City of Mississauga

City Department and Agency Comments

Date Finalized: 2021-08-11 File(s): A322.21

Property Address: 506 Arrowhead Road

Appendix 1 – Transportation and Works Comments

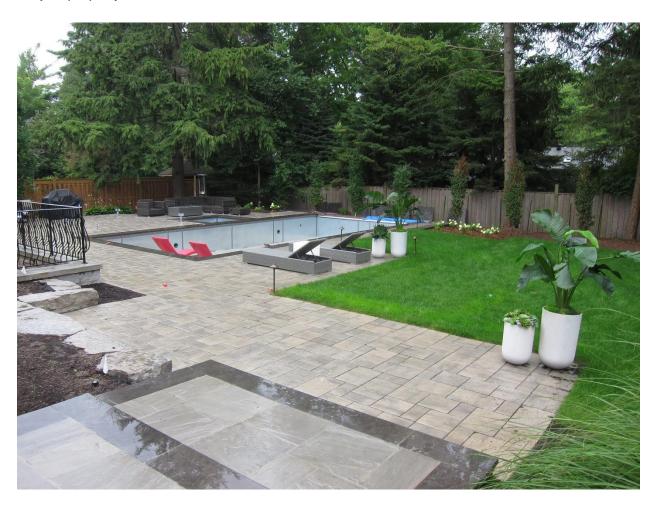
Enclosed for Committee's easy reference are photos showing the existing rear yard of the subject property.
